**Plugging and Abandonment Procedure
Horseshoe Gallup Unit No. 8
Attachment "A"**

Re: Permanent Abandonment

Well: 8 Horseshoe Gallup Unit

**BLM FLUID MINERALS
Geologic Report**

WELL NAME 8 HGU
 SEC, TWN, RNG. 30-31N-16W

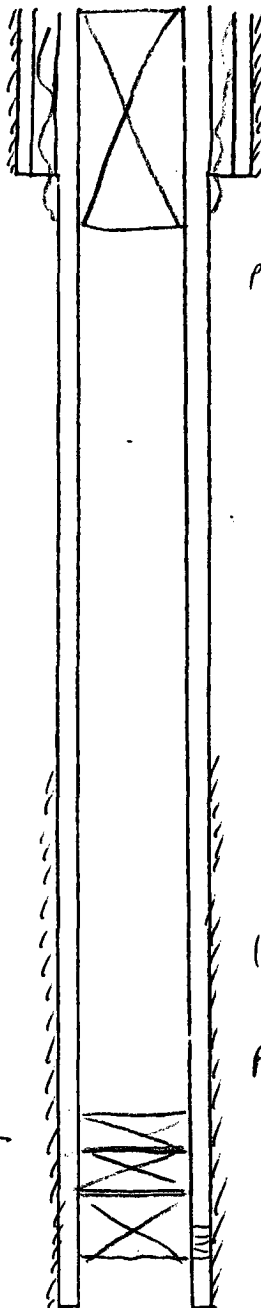
a) Bring the top of the Gallup plug to 1014'.

b) Place the Surface plug from 152' to surface inside and outside the 5 ½" casing.

- BLM geologist's pick for the top of the Gallup fm. reflects the top of the transitional Tocito interval in this well. This top varies from operator's pick in this well.

- It is recommended that the Gallup plug be extended upward to adequately isolate the Gallup top identified in this report.

plug 152 - surface w/ 50 SKS

$$(1275 - 1014) + 50 / 7.299 (1.18) = 36 \text{ SKS or greater}$$

plug 1275 - 1014'
